1370 STEWART ST

PRIORITIES & BOARD RECOMMENDATIONS

After visiting the site, considering the analysis of the site and context provided by the proponents, and hearing public comment, the Design Review Board members provided the following siting and design guidance.

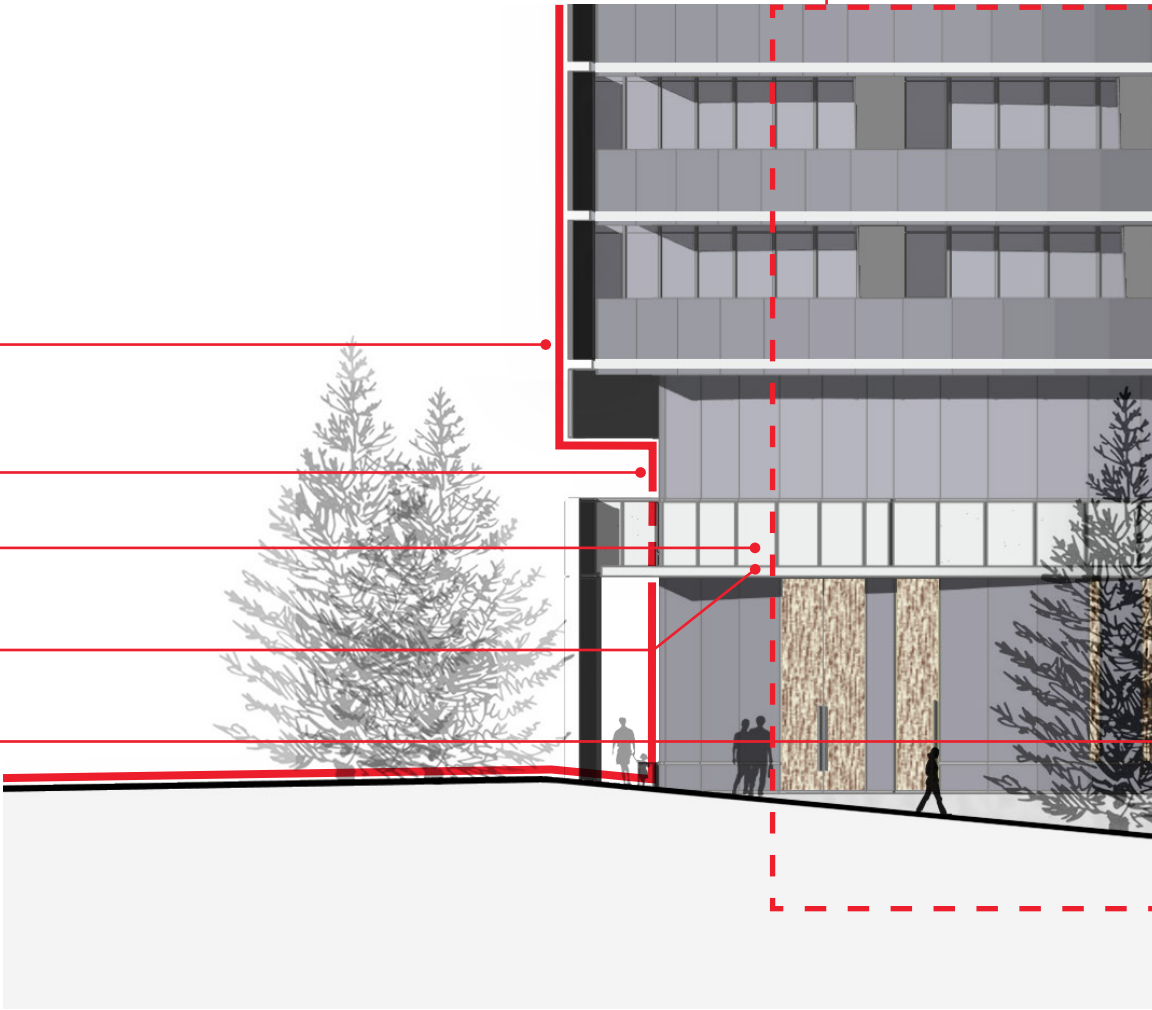
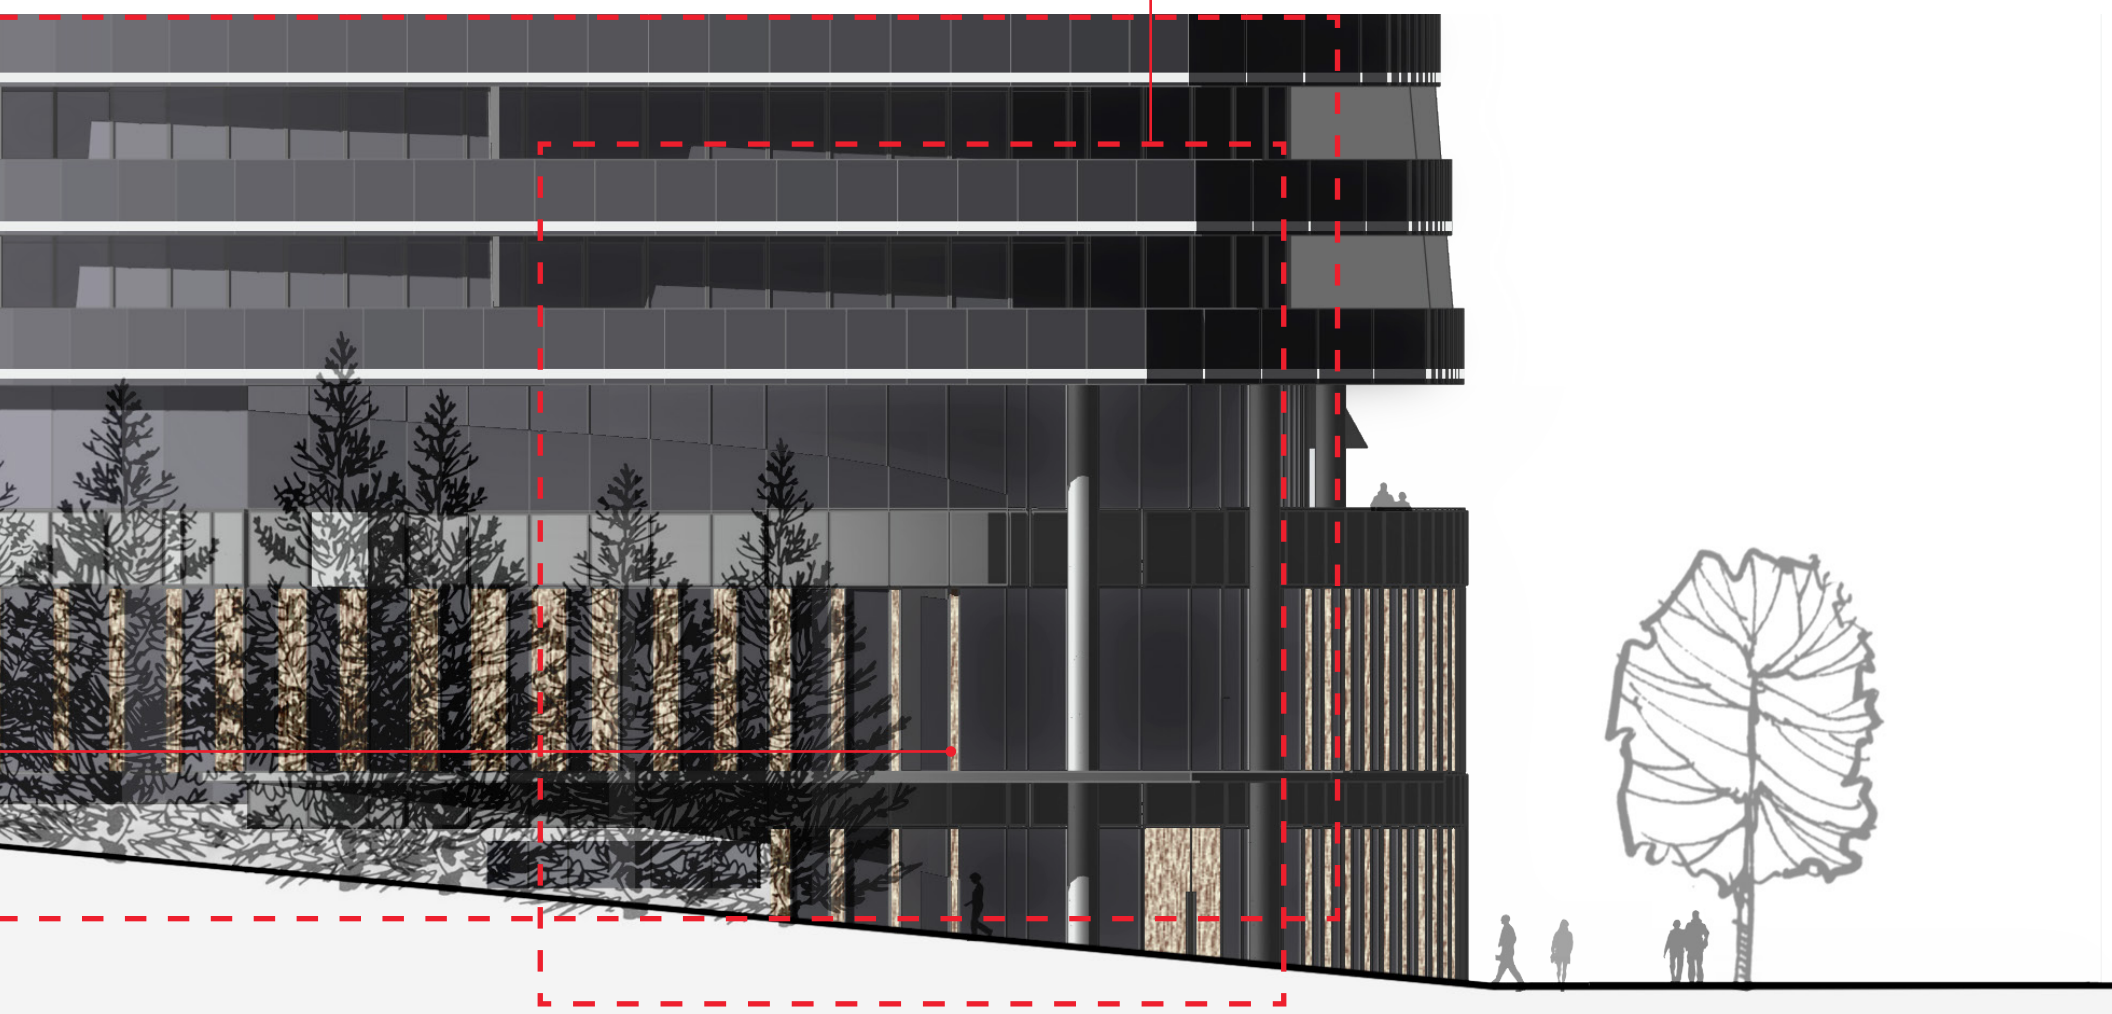
5B. The Board neither supported nor opposed the ‘glass box’ expression of the podium. The Board agreed that although there is no context precedent that would support this choice, the unique location at this unusual triangular site adjacent to I-5 would support a wide variety of solutions, including one not directly connected to context. (CS2-A, CS2-4, CS3-A-2)

5C. Regardless of the direction the podium design takes, the Board asked to see a clear design connection between the materiality of the base and the tower. The design should express a logical scheme for human scale elements in the pedestrian zones. (DC2-2, DC2-3)

SCALING ELEMENTS
Skin recess and material change
differentiate podium from tower.

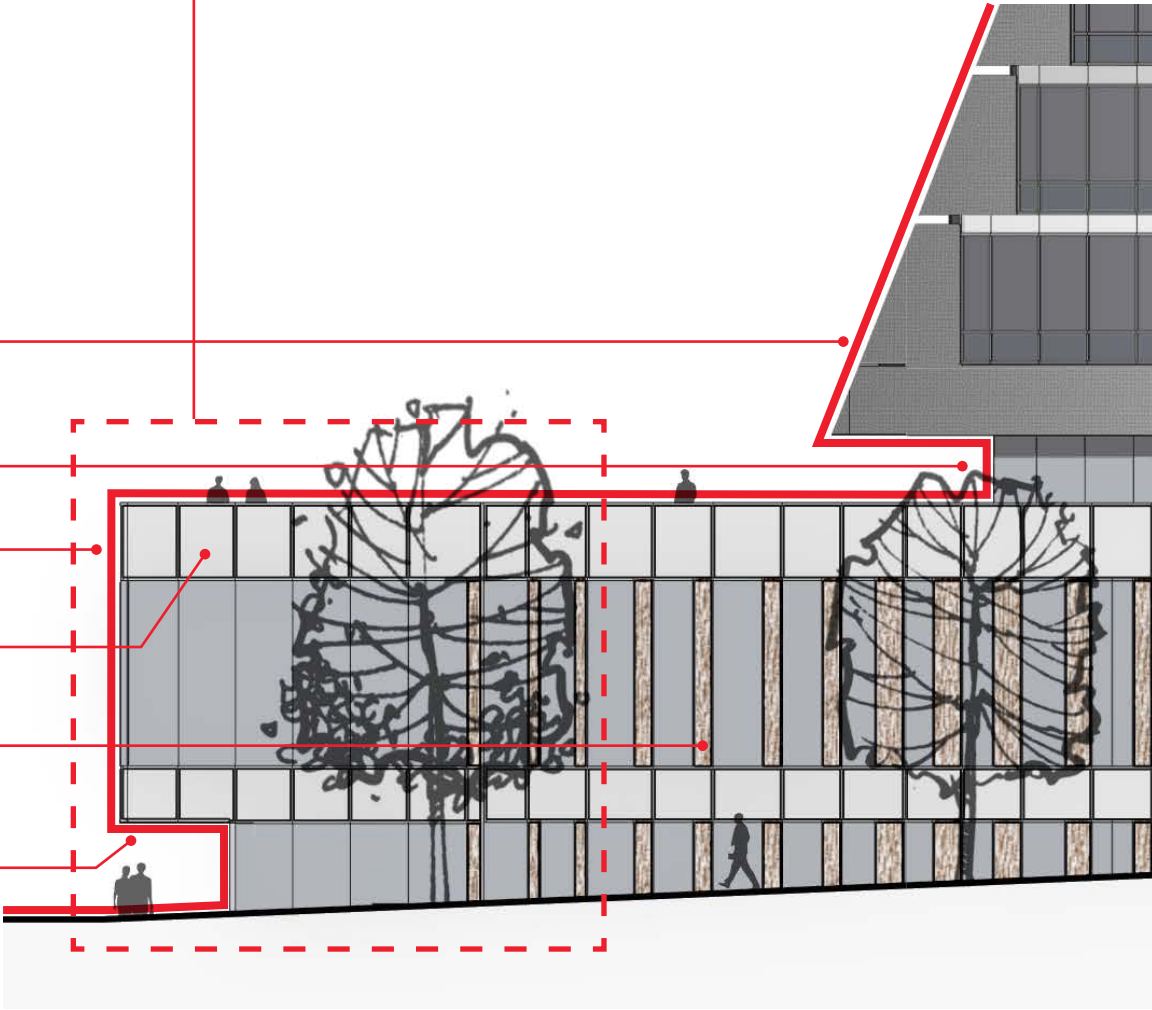
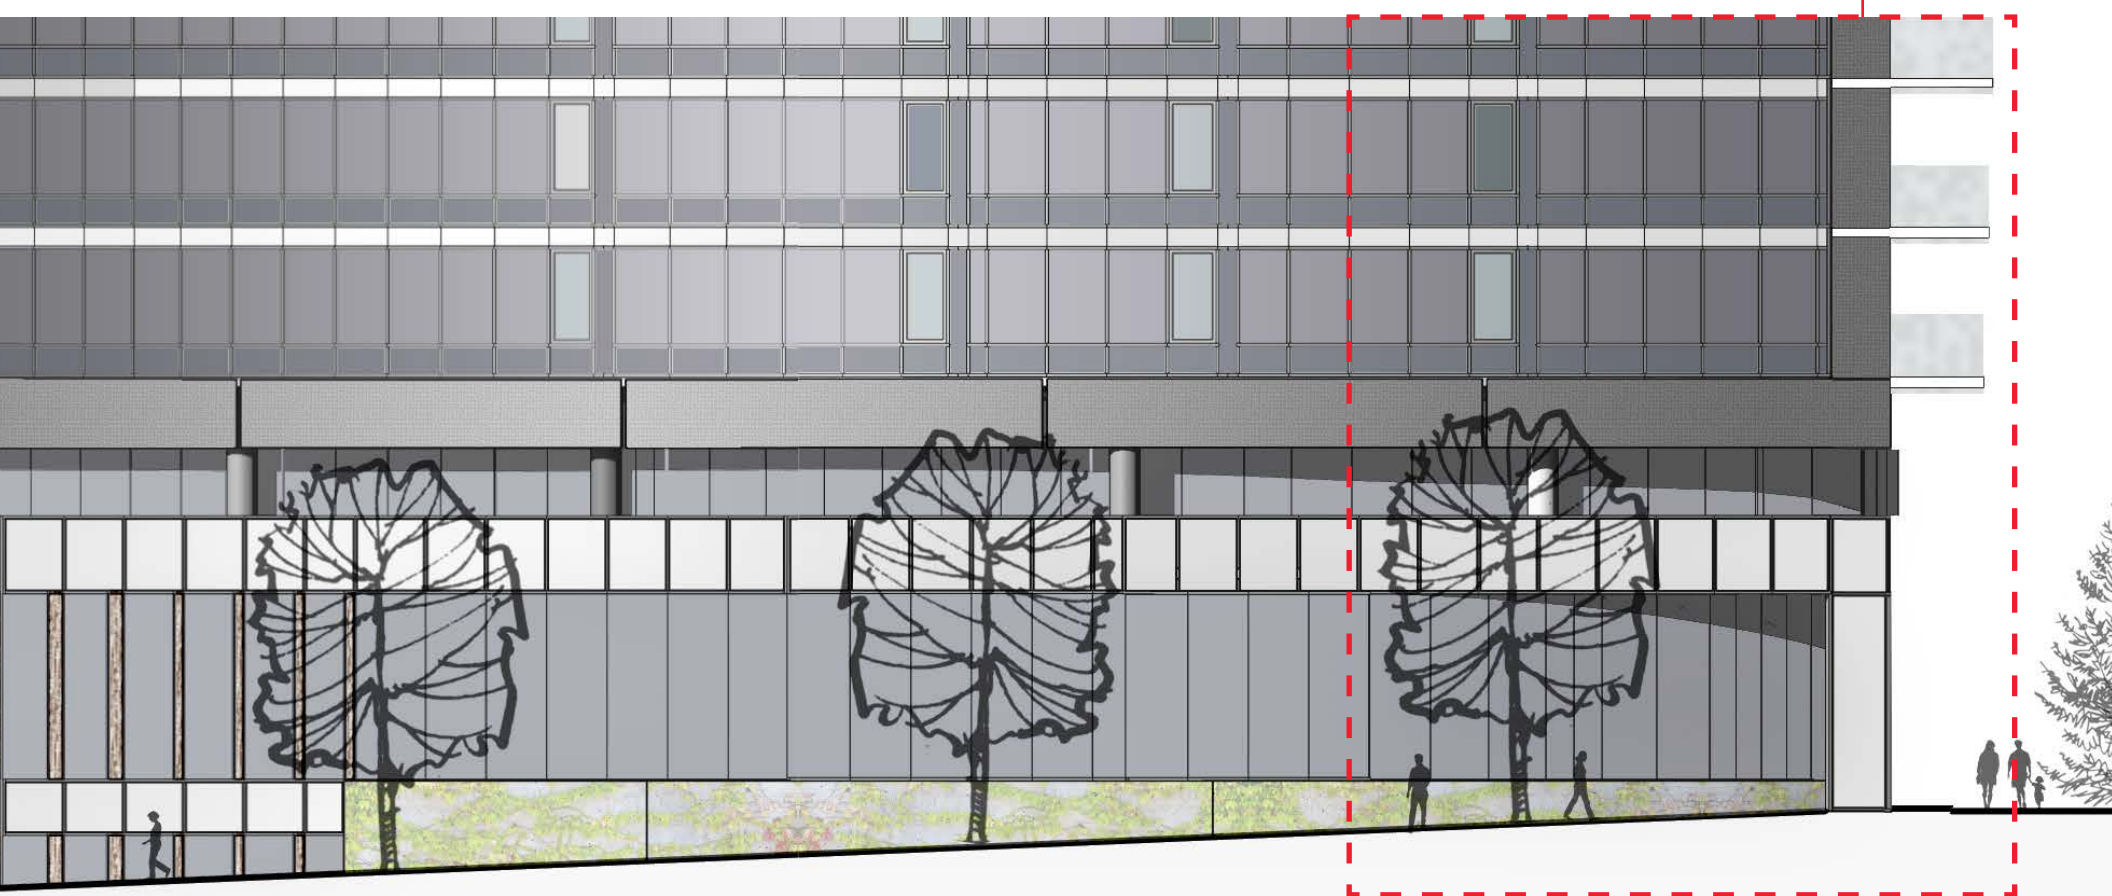
5B. The Board neither supported nor opposed the ‘glass box’ expression of the podium. The Board agreed that although there is no context precedent that would support this choice, the unique location at this unusual triangular site adjacent to I-5 would support a wide variety of solutions, including one not directly connected to context. (CS2-A, CS2-4, CS3-A-2)

5C. Regardless of the direction the podium design takes, the Board asked to see a clear design connection between the materiality of the base and the tower. The design should express a logical scheme for human scale elements in the pedestrian zones. (DC2-2, DC2-3)

SCALING ELEMENTS
Skin recess and material change differentiate podium from tower.
